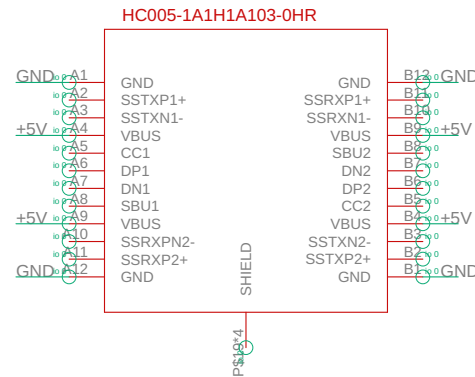
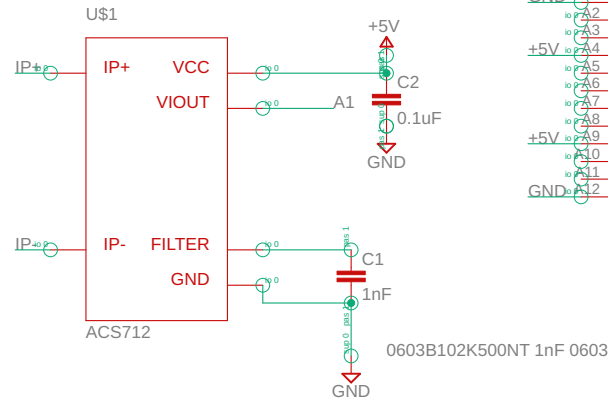
insufficient number of pins, consider to use a port expander via I2C!

1602 I2C LCD
LCD <=> Arduino
3.3 V <=> 3.3V
GND <=> GND
SDA <=> A4
SCL <=> A5
